Lahontan Regional Water Quality Control Board

August 2, 2013

REQUEST FOR AN ACTION PLAN AND MORE INFORMATION IN REPORTS REQUIRED BY CLEANUP AND ABATEMENT ORDER NO. R6V-2008-0002 AND INVESTIGATIVE ORDER R6V-2013-0041

PACIFIC GAS AND ELECTRIC (PG&E) COMPRESSOR STATION, HINKLEY, SAN BERNARDINO COUNTY (WDID 6B369107001)

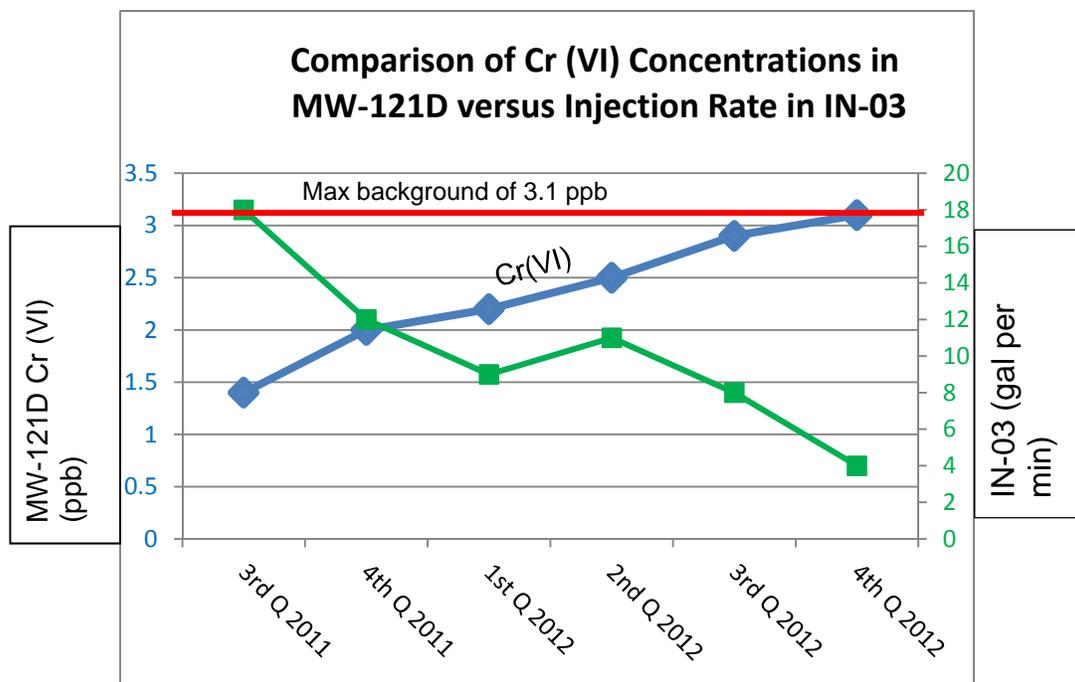
c. Amend Table 2-11 to show the total calculation of all columns for the quarter being reported.

The revised Table 2-11 contained in Attachment 1 to the report was not amended to include the total calculations during first quarter 2013 for four columns: total days in period pumping, % of period actively pumping, average injection rate when pumping, and average injection rate for period.

1. Explanation of why the twelve compounds previously approved for use are no longer being used to improve well efficiency in the Northwest Freshwater Injection System.
2. Explanation on why no well development chemicals were used in IN-03 during fourth quarter 2012 and first quarter 2013 even though there was a more than 50% flow rate reduction from the previous two quarters.
3. Concentrations (by date of discharge) of chemicals discharged into each of the injection wells
